IN THE DRAWINGS

REMARKS

Appl. No. 09/749,088
Amdt. Dated 07/11/2005
Reply to Notice of Allowance of 05/06/2005

FIG. 3

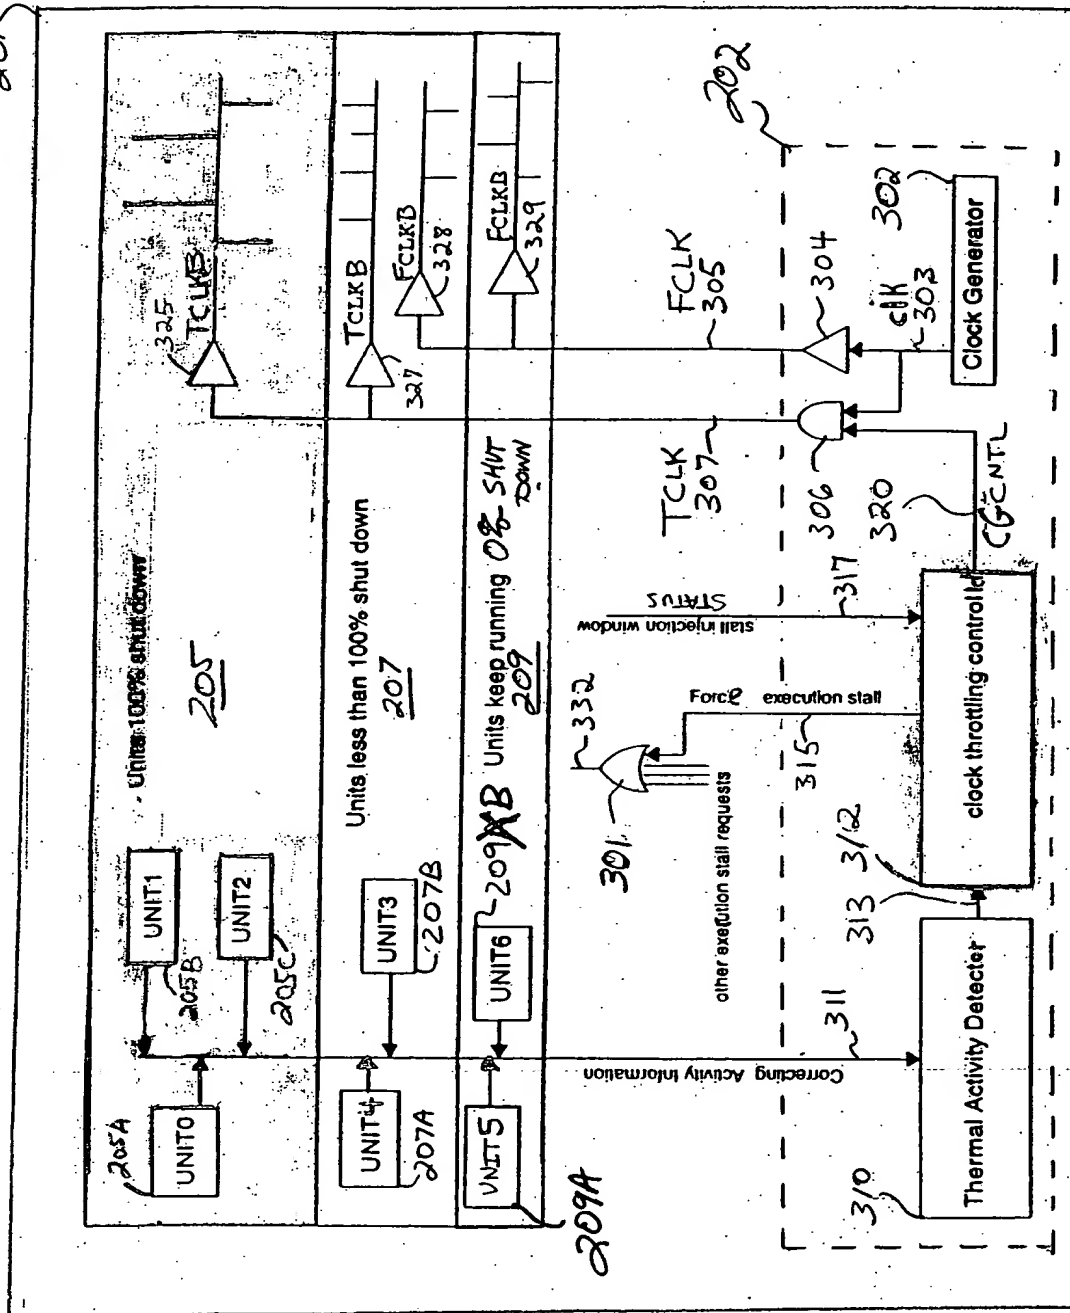
Figure 3 is amended as follows:

The reference number "209A" is corrected to --209B-- for "Unit 6" in accordance with the specification at page 7, lines 14-16. [Pub. No. US 2002/0083354 A1, para. no. 0020].

Reference number --209A-- is added to "Unit 5" in accordance with the specification at page 7, lines 14-16.

Figure 3 has been amended to correct the reference number "209A" to --209B-- for "Unit 6" and add reference number --209A-- is added to "Unit 5" in accordance with the specification at page 7, lines 14-16. [Pub. No. US 2002/0083354 A1, para. no. 0020].

FIG. 4

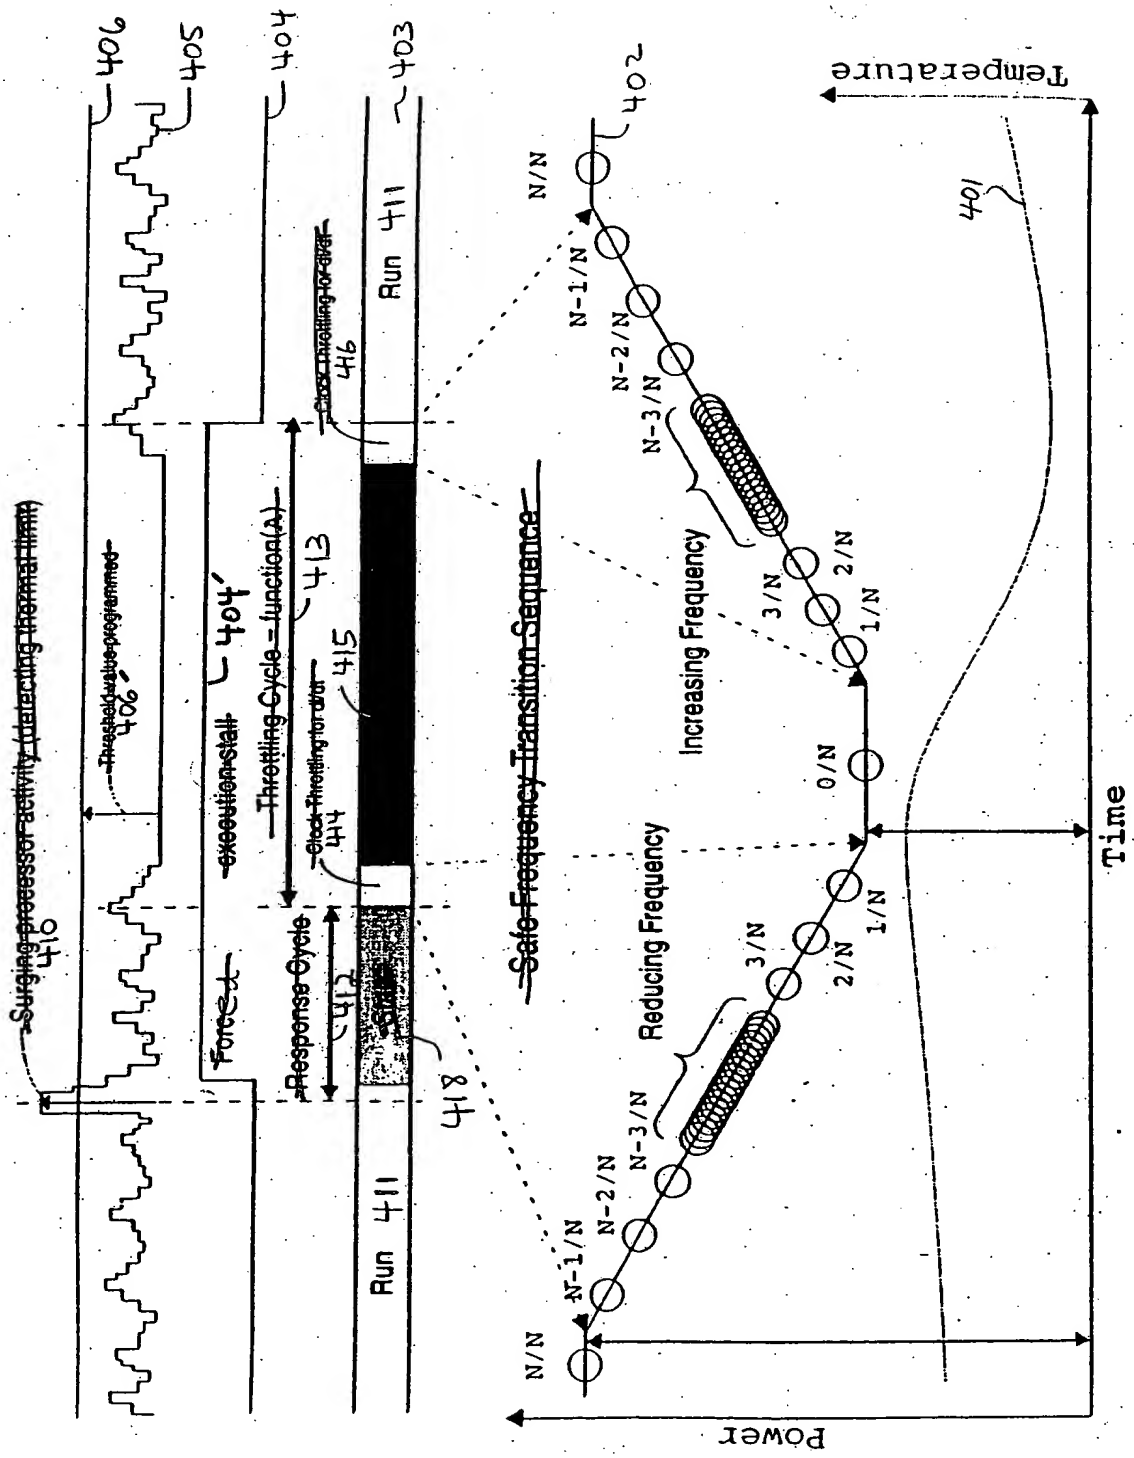
Figure 4 is amended as follows:

Text on the drawing of Figure 4 has been deleted with portions thereof being added into the specification.

A duplicate reference number "206" is corrected to --206'-- with the specification being updated accordingly.

Reference number --404'-- is added to the waveform 404 to illustrate the assertion of the forced execution stall signal with the specification being updated accordingly.

Figure 4 is amended to delete some text from the drawing, correct a duplicate reference number "206" to --206'--, and add a reference number --404'-- to waveform 404 to illustrate the assertion of the forced execution stall signal with the specification being updated accordingly.

The three paragraphs (Pub. No. 2002/0083354, Para. Nos. 0025-0027) starting at Page 10, line 14, and continuing to page 11, line 29 are amended to add deleted text from the drawing of Figure 4, add the corrected reference number 406' from the drawings, and correct grammatical errors in the specification. These corrections to the specification are consistent with the amendment to the drawing of Figure 4.

The paragraph beginning at page 12, line 3, (Pub. No. 2002/0083354, Para. No. 0029) is amended to add a corresponding reference number 404' into the specification for the assertion of the forced execution stall signal in waveform 404. This correction to the specification is consistent with the amendment to the drawing of Figure 4.

FIG. 6

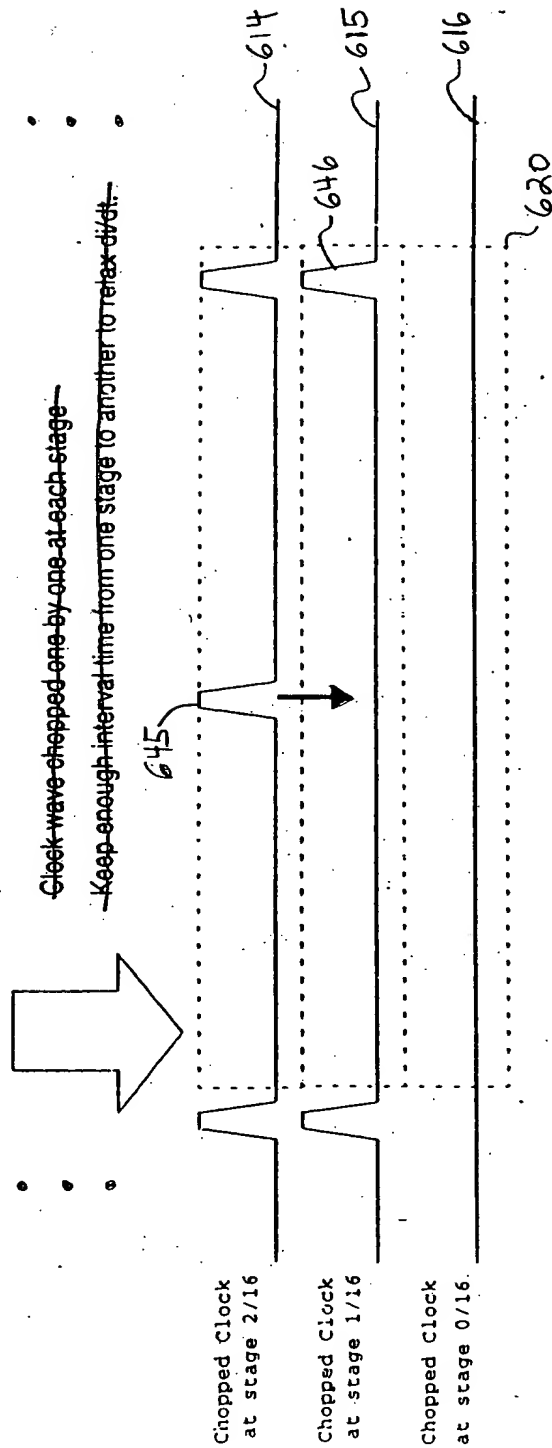
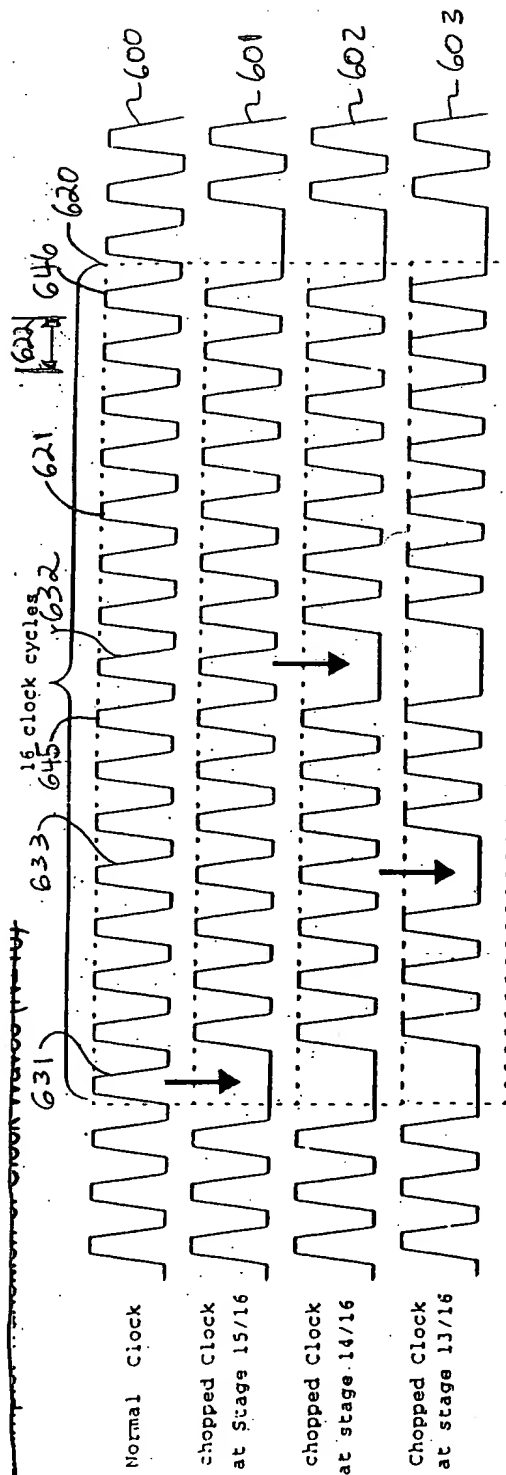
Figure 6 is amended as follows:

Text on the drawing of Figure 6 has been deleted with portions thereof being added into the specification.

Figure 6 is amended to delete text on the drawing.

The paragraph beginning at page 17, line 30, (Pub. No. 2002/0083354, Para. No. 0043) is amended into two paragraphs and includes amendments to add deleted text from the drawing of Figure 6, and correct grammatical errors in the specification. This correction to the specification is consistent with the amendment to the drawing of Figure 6.
